**INTERNATIONAL CODE COUNCIL (ICC)
Code Technology Committee (CTC)**

Area of Study – Climbable Guards

**Draft Interim Report No. 2 of CTC Recommendations and
Public Hearing Announcement**

E97-06/07

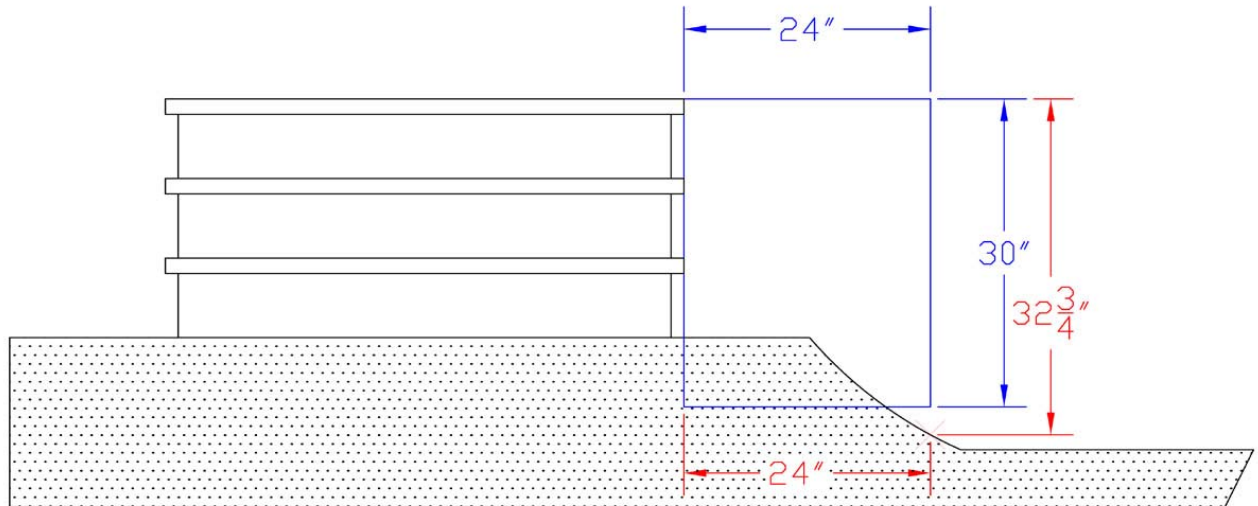
The diagram below was drawn by the author and is shown as a visual guide or technical drawing. The drawing shows a 3 riser front entry stoop with 7-3/4" risers from a front elevation. The ground is detailed in outlined dots. The 24" horizontal with 30" vertical box shows the area in which the code change submits the measurements should be taken. The 32-3/4" vertical point shows the deepest point within the 24" horizontal edge measurement.

Thus if this stoop was on a home it would require a guard be installed on the right side only as the left side is not 30 inches or more deep.

Staff note: *In order to reflect the proposed CTC modification, the horizontal distance of 24" should be revised to 36".*
